STINGER OPERATION IMPROVEMENT

DOCUMENT	STINGER OPERATION IMPROVEMENT
MACHINE/ GROUP	SIMBA M-L-E
DOCUMENT AUTHOR	Gordon Taylor
DATE	11/09/2023

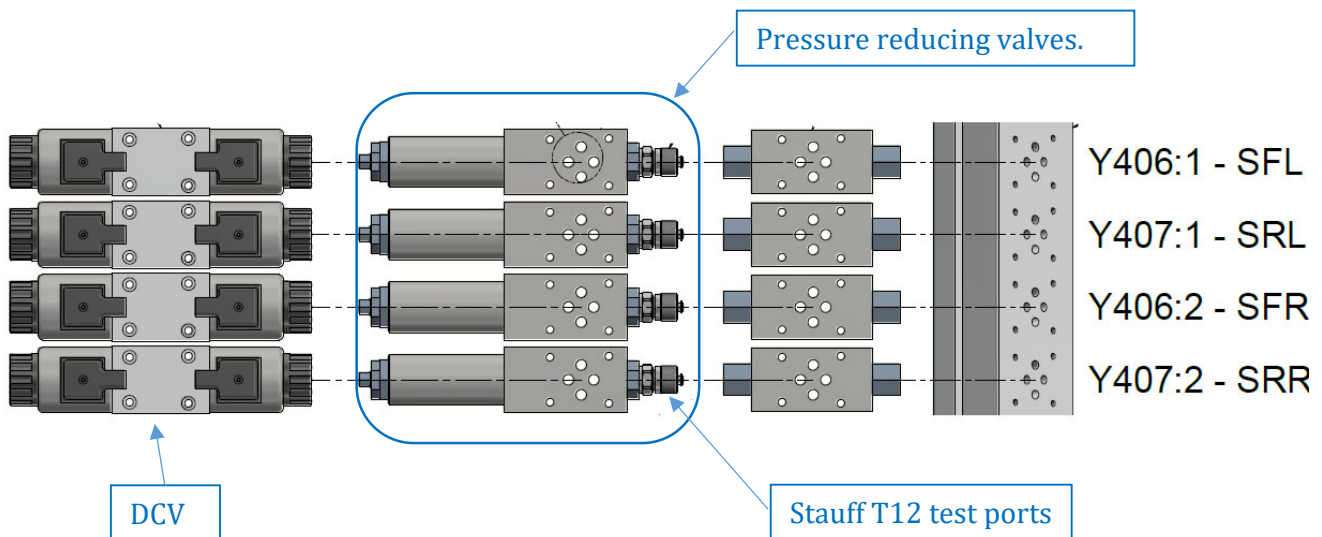
All post-Mark 8 Epiroc Simbas with stinger cylinder stabilization were fitted with P port pressure reducers in hopes to assist the feed transition in ABC total operation to be as smooth as possible, while the pre-Mark 8, featured A port pressure reducers on all four stingers. According to the original equipment manufacturer (OEM) specifications, the front stingers should extend with a pressure of 30 bar, and the rear stingers should extend with a pressure of 60 bar.

On all machinery post-Mark 8, P port pressure reducers are limited to using this reduced pressure of either 30 or 60 bar to retract the stingers. In cases where the stingers accumulate cuttings from drilling, they may fail to return to their home position and become jammed. This situation necessitates the operator to either clean out the stingers or manually push them against the mine walls to retract them. This operational issue negatively impacts the drill's ability to maintain a continuous drilling cycle in ABC total, as the stingers fail to reach the anchor sensor position.

Alternatively, transitioning to A port pressure reducers enables the stingers to utilize the reduced pressure of 30 bar at the front and 60 bar at the rear for extension. However, it also allows for the full pump pressure to be employed for retracting the stingers. In most scenarios, this higher retraction pressure can effectively clear any cuttings ingress and aid the hydraulic cylinders in returning the stingers to the anchor position. This adjustment facilitates uninterrupted ABC total drilling operations. Maintenance Technique can also supply upgraded stingers with improved sealing to prevent cuttings ingress- contact parts@mtunderground.com for more information.

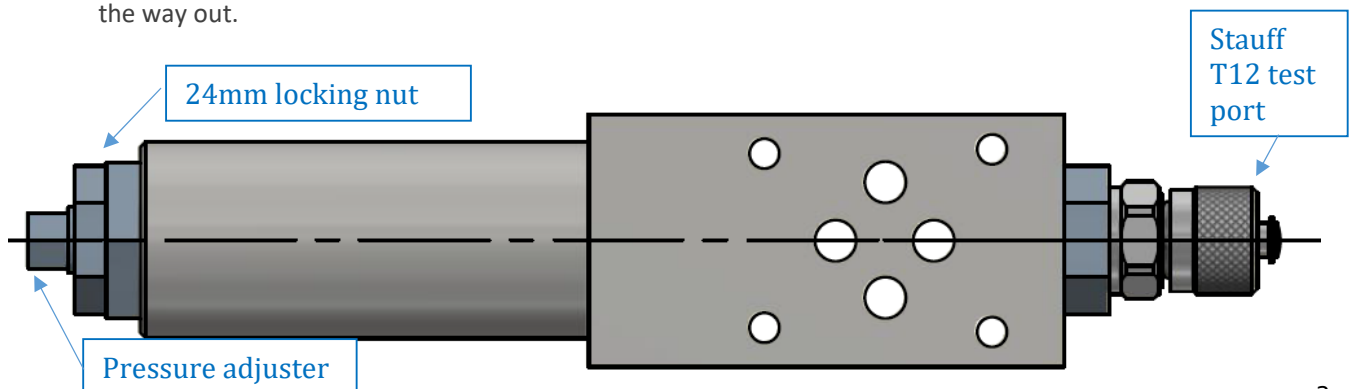
1. Position the feed so that you can access the rod handling box safely and extend all stingers to their maximum stroke without contacting anything and isolate the machine.
2. Access the rod handling box and locate the Y406 and Y407 stinger valving.
3. Using a 5mm Allen key, remove valves one at a time and replace the P port pressure reducer with the **MT3217 9341 60** A port pressure reducer. Note these valves have an offset bolt pattern and can only be fitted in one orientation. Replace all O-rings **MT5507 8719 00** between mating faces. Warning- pressure can be retained at the valving due to the stinger check valves, care should be taken when removing valves from the manifold.

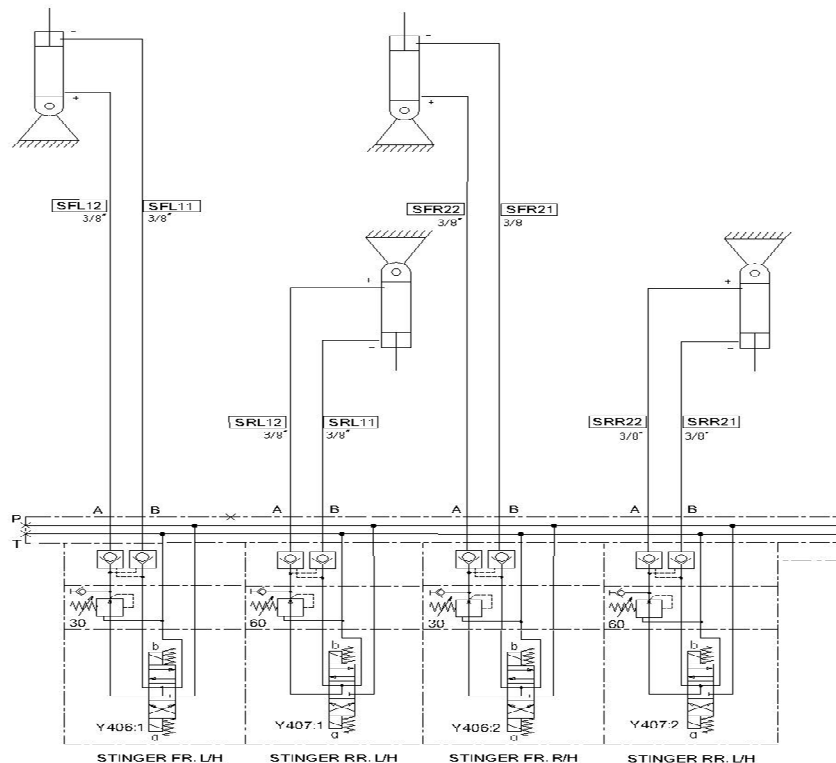
Check that stinger pressure is reduced for extending of the stingers and max pressure is available for retracting the stingers. Note- the test port will now only read the reduced pressure (A port) in one direction. If stinger pressure is reduced on retraction and not on extension it will be necessary to swap the hoses at the stingers. Do not swap the DIN plugs at the valve.

PLEASE NOTE: A-Port pressure reducing valves fitted to stinger cylinders to improve retract times inline with ABC Total dependencies
